IMPORTANT SAFETY RECALL

NHTSA Recall No. 23V-396

Terex Utilities	
SAFETY NOTICE	SN719

SUBJECT: Subframe Insert Welds

Figure 1. Area of subframe to inspect

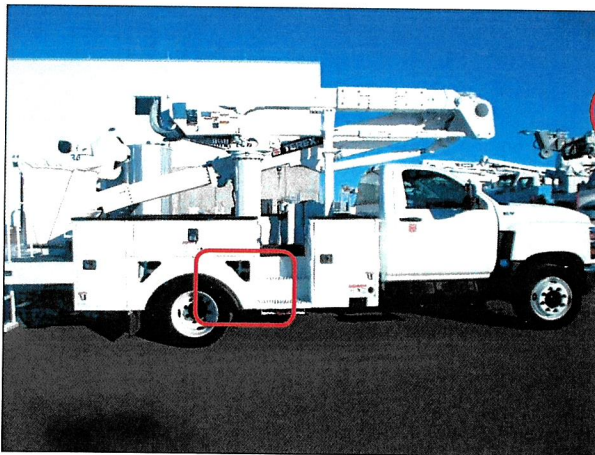
1. Immediately inform all users, operators, and supervisors that the bottom side of the subframe where the aerial device mounts must be visually inspected before further use.
2. Inspect to determine if welds are cracked for the threaded inserts using the information in the bulletin as reference.
3. If no cracks are detected during the visual inspection the unit can be used following the instructions in the continued use section in the bulletin as well as all operator, maintenance, and inspection requirements as specified in the manuals.
4. If cracking is detected in the welds, do not use the machine and contact Terex Utilities Warranty Department using the contact information in the bulletin.

1. Immediately inform all users, operators, and supervisors that the bottom side of the subframe where the aerial device mounts must be visually inspected before further use.
2. Inspect to determine if welds are cracked for the threaded inserts using the figures below as reference.

3. If no cracks are detected during the visual inspection the unit can be used following the instructions in the continued use section in this bulletin as well as all operator, maintenance, and inspection requirements as specified in the manuals.
4. If cracking is detected in the welds, do not use the machine and contact Terex Utilities Warranty Department using the contact information in this bulletin.

Figure 2. Weld to inspect

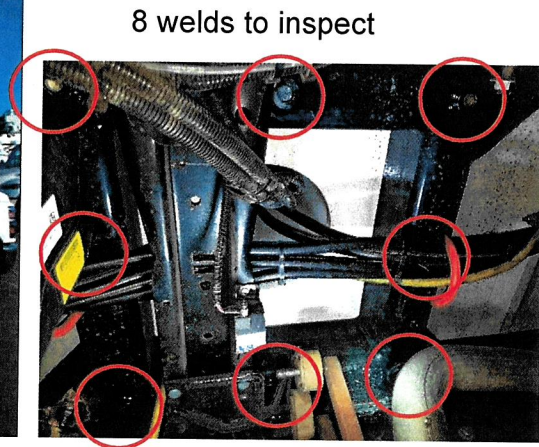
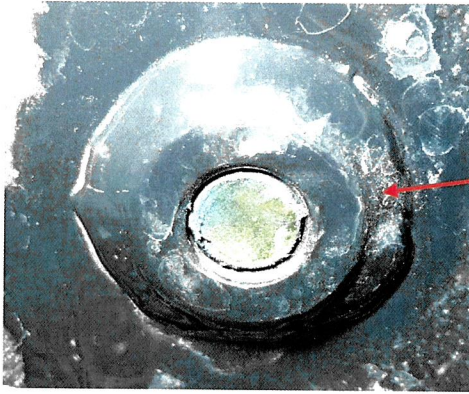
Inspect this weld
for cracks

Terex will complete Field Service Kit Z1650 at no cost to the customer. The Field Service Kit Z1650 provides instructions for removing the welds for the threaded inserts at the top of the subframe and to reweld the top side of the inserts to the subframe tubes.
